Model: BRG-MF1a	Date: 18-Oct-12	No.: RJ030001j
-----------------	-----------------	----------------

Subject: Firmware Release Note: Engine/Controller		Prepared by: J. Mochizuki	
From: 3rd Tech Service Sect., MFP/Printer Tech Service Dept.			
Classification:	<input type="checkbox"/> Troubleshooting <input type="checkbox"/> Mechanical <input type="checkbox"/> Paper path <input type="checkbox"/> Product Safety	<input type="checkbox"/> Part information <input type="checkbox"/> Electrical <input type="checkbox"/> Transmit/receive <input checked="" type="checkbox"/> Other (Firmware)	<input type="checkbox"/> Action required <input type="checkbox"/> Service manual revision <input type="checkbox"/> Retrofit information <input checked="" type="checkbox"/> Tier 2

Model: BRG-MF1c		Date: 19-Aug-15	No.: RJ032004
Subject: New covers to minimize static electricity		Prepared by: J. Kitagawa	
From: 1st Tech Service Sect., MFP/Printer Tech Service Dept.			
Classification:	<input type="checkbox"/> Troubleshooting <input type="checkbox"/> Mechanical <input type="checkbox"/> Paper path <input type="checkbox"/> Product Safety	<input checked="" type="checkbox"/> Part information <input type="checkbox"/>

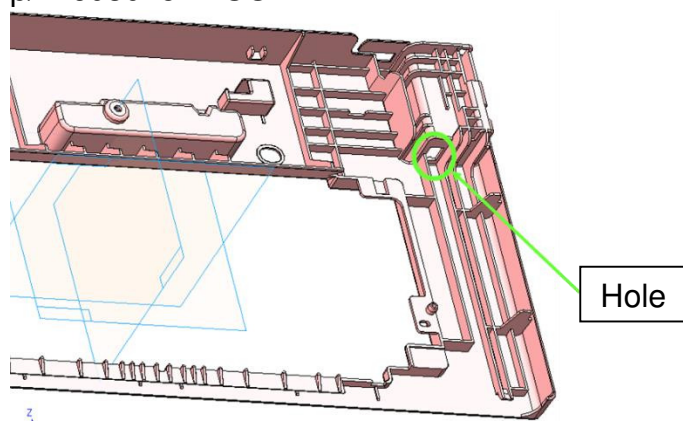
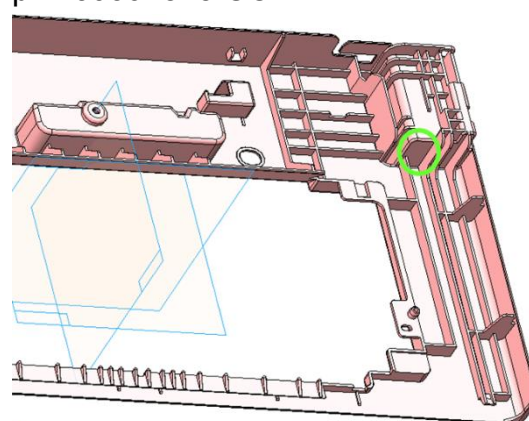
- A hole in the rear cover was filled.
- A projection on the right side plate was removed.
- The Mylar does not have to be attached to the new rear cover. (The Mylar is needed only for the old rear cover.)

Reason: To further minimize static electricity

Important: The new Rear Cover can be installed only on units that have the new Right Side Plate. See the next page for an illustration of the right side plate and serial number information.

Old part number	New part number	Description	Q'ty	Int	Page	Index	Note
J0301541	J0301545	COVER:REAR:MF	1 → 1	X/X	5	10	
J0301544	-	SHEET:HINGE:RIGHT:MF	1 → 0
